VALUE ENGINEERING REPORT

SR 20 Widening
Forsyth and Gwinnett Counties
STP-0002-00(392); PI No.: 0002392
BRST-054-1(63); PI No.: 132985
MLS-000-00(430); PI No.: 0004430

December 18, 2007

G-1.1
Pg 3/9

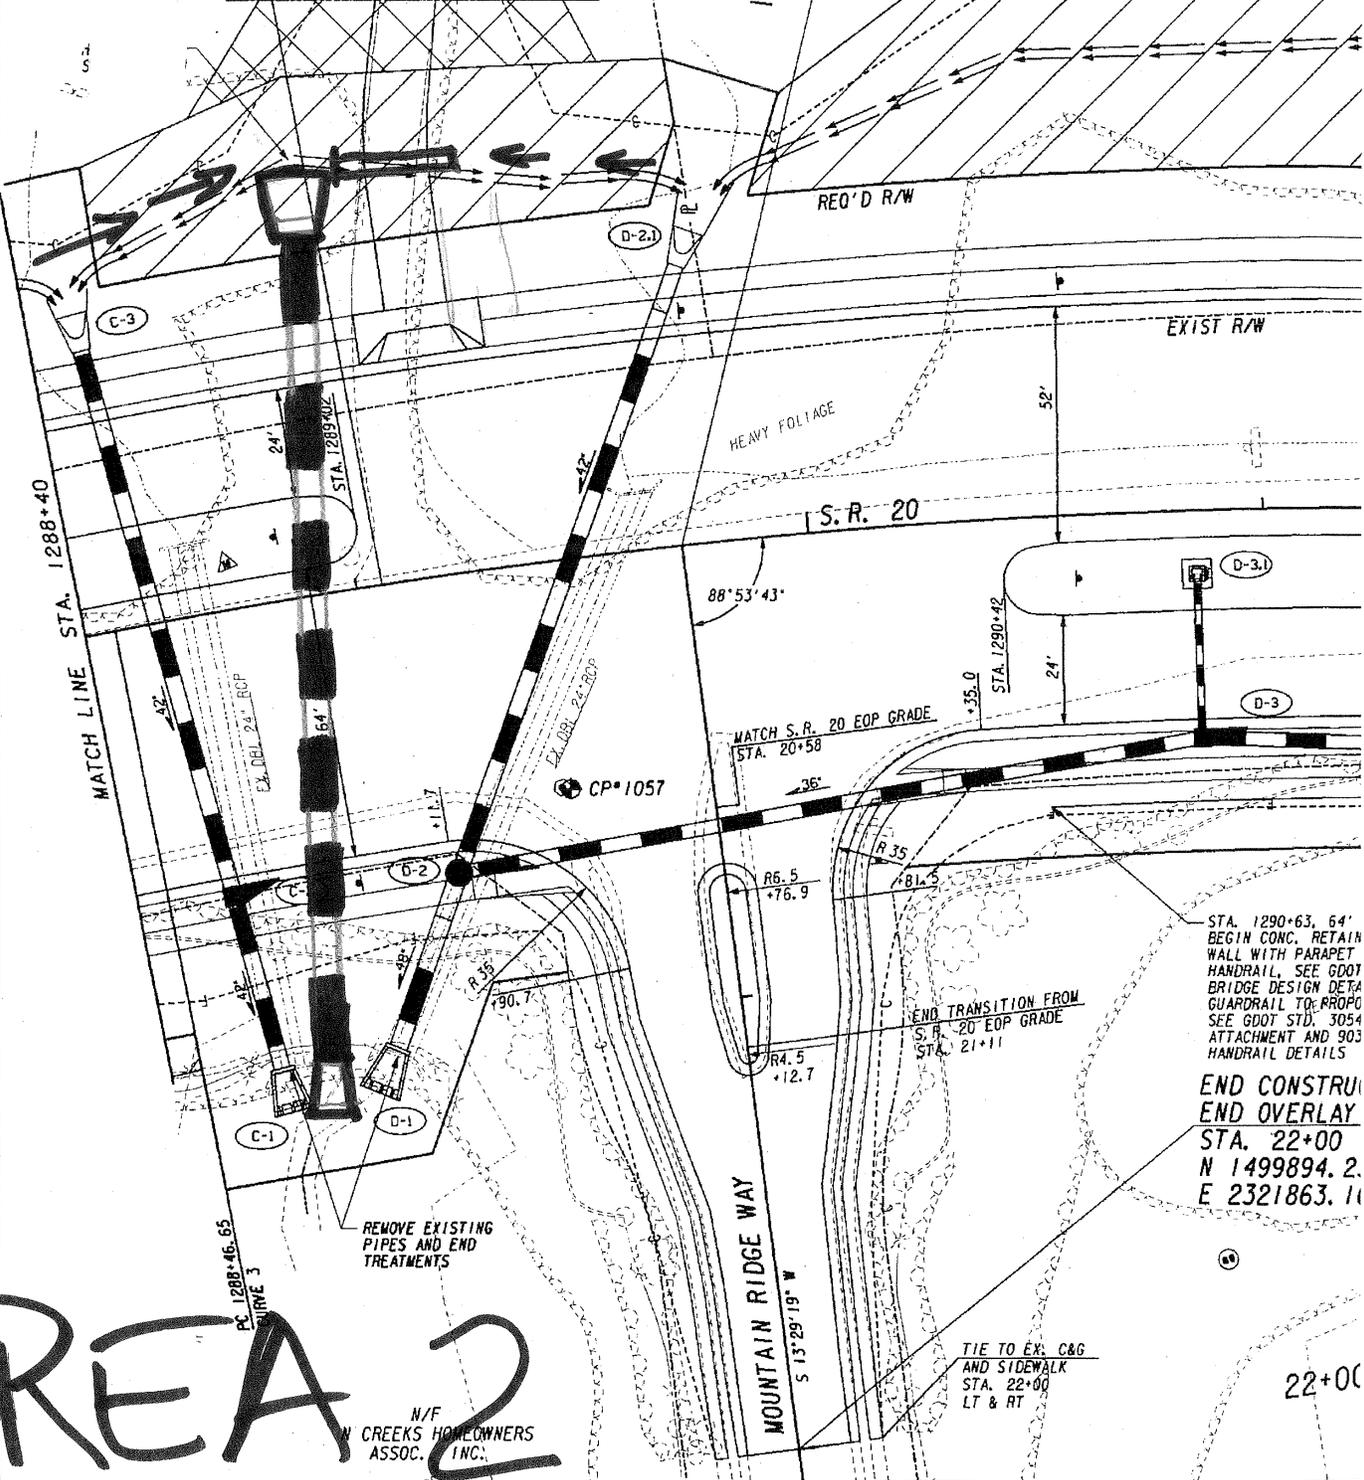
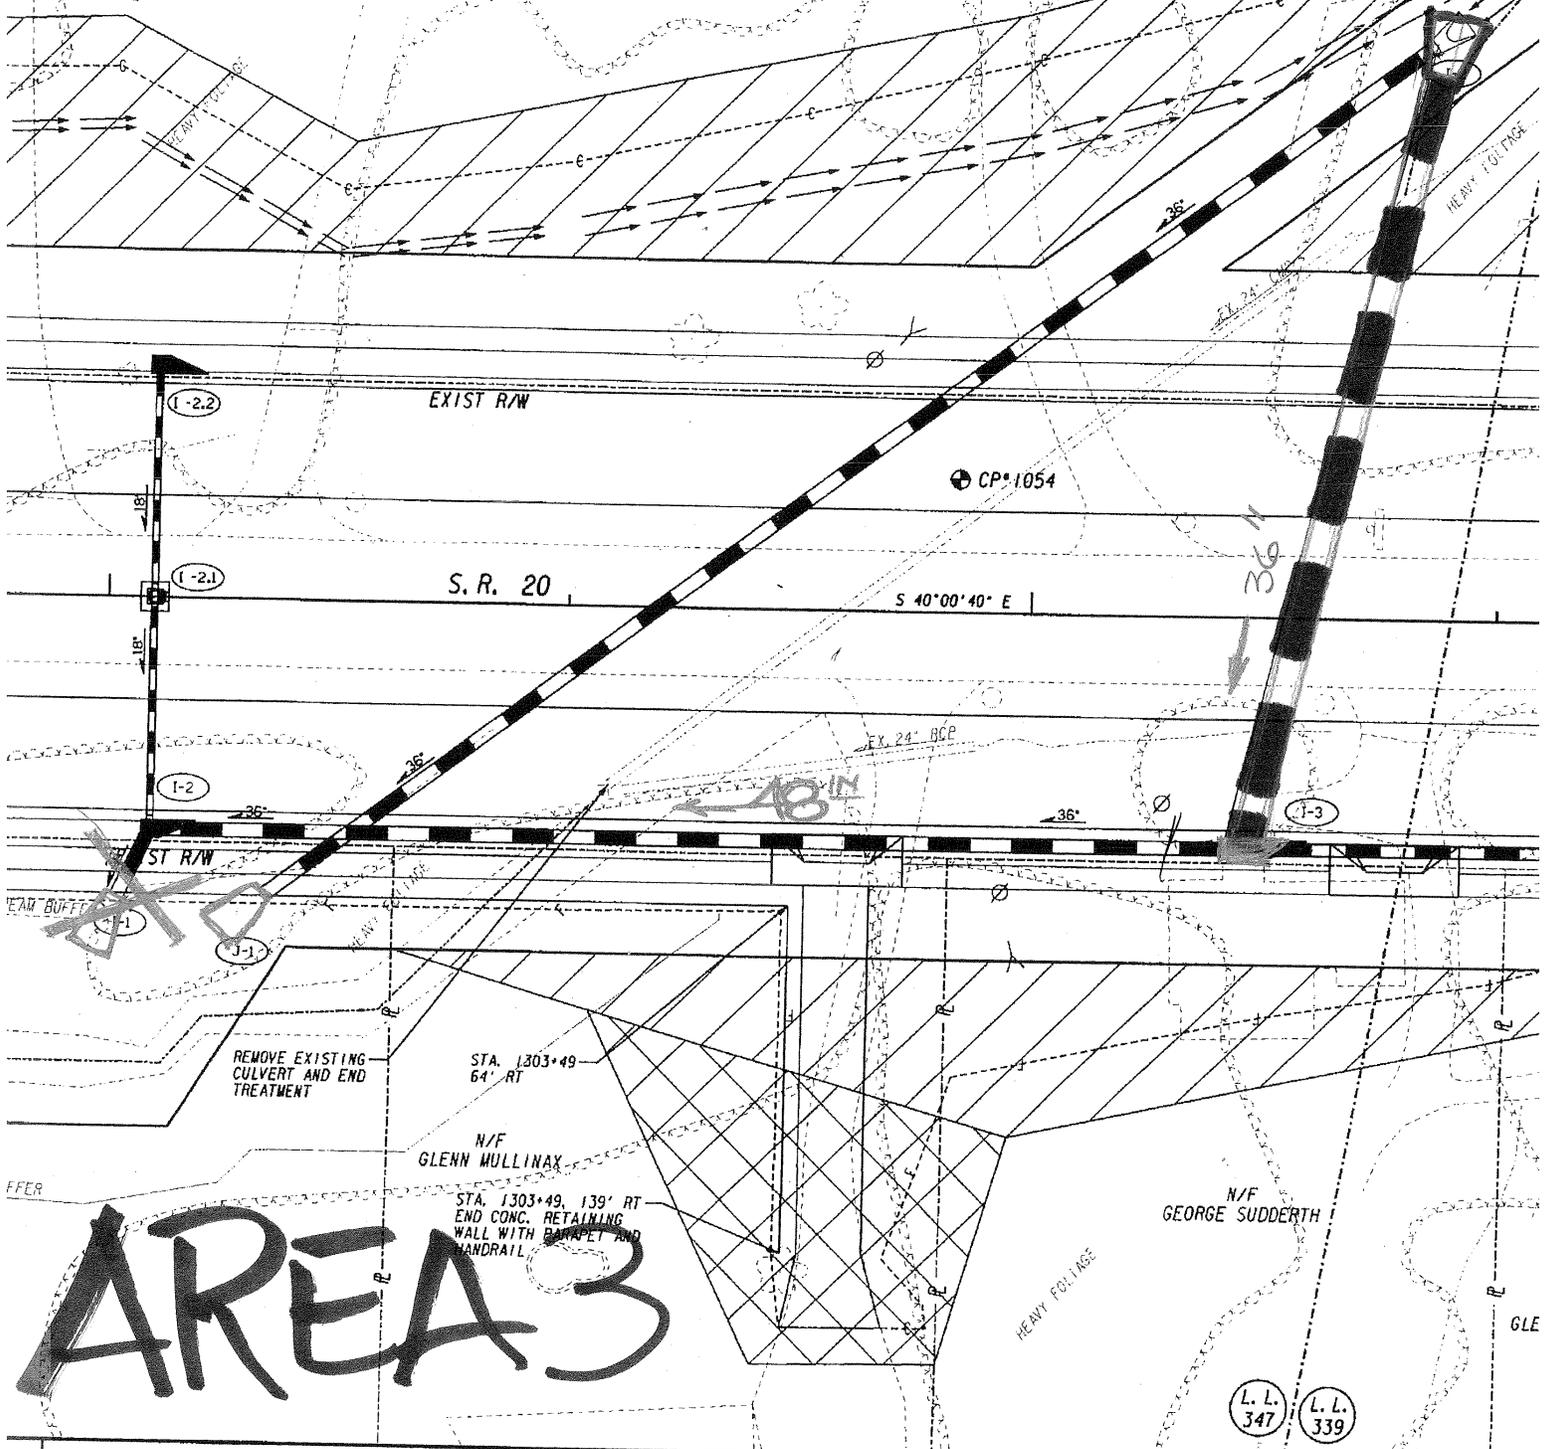
Project 3, PI 0004430, Gwinnett County, sta 1467+00.
At this location, shifting the 18 crossing pipe and inlets and realigning the 48 inch outlet pipe can save a drainage structure and shorten the pipe run while providing a similar drainage scheme.

G-1.3
P 17/19

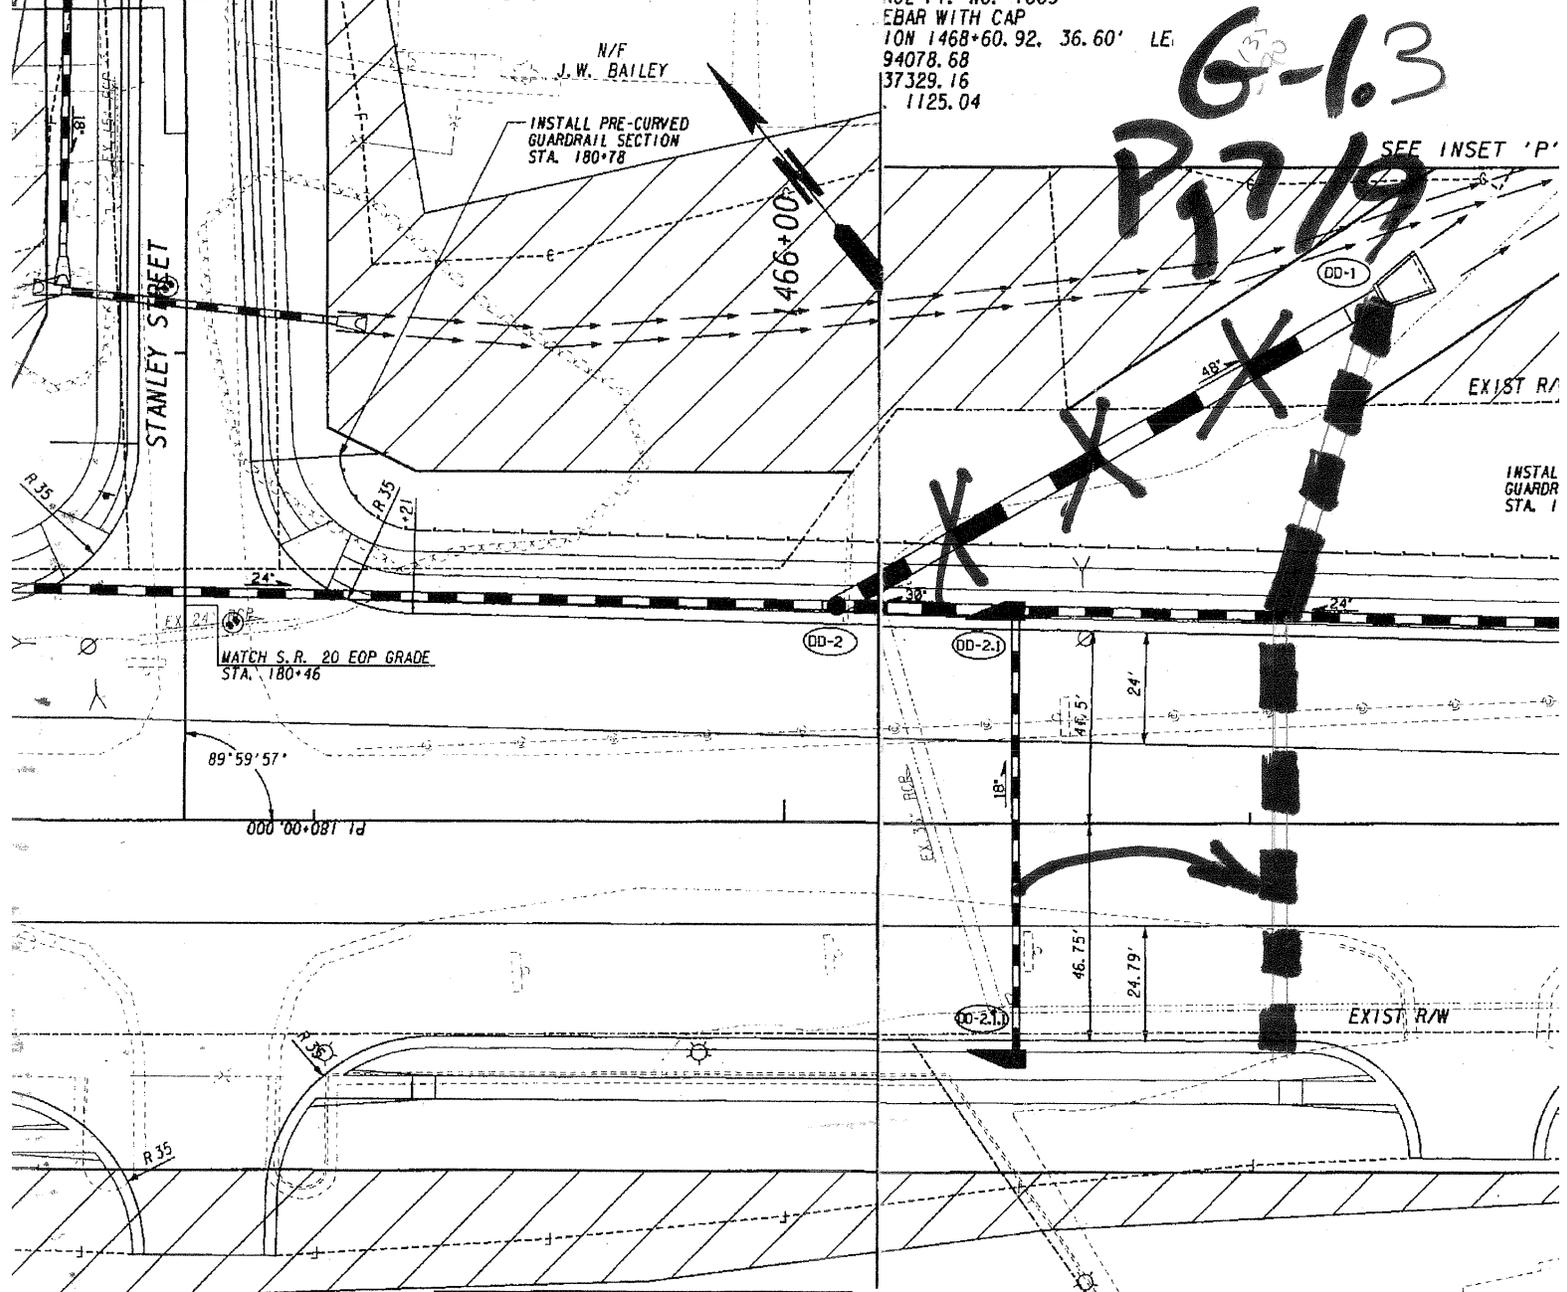
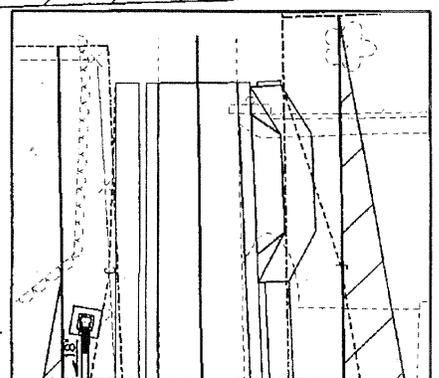
Six separate areas of the project were evaluated to economize on the storm drain piping either by shortening runs, eliminating pipe or combining elements.
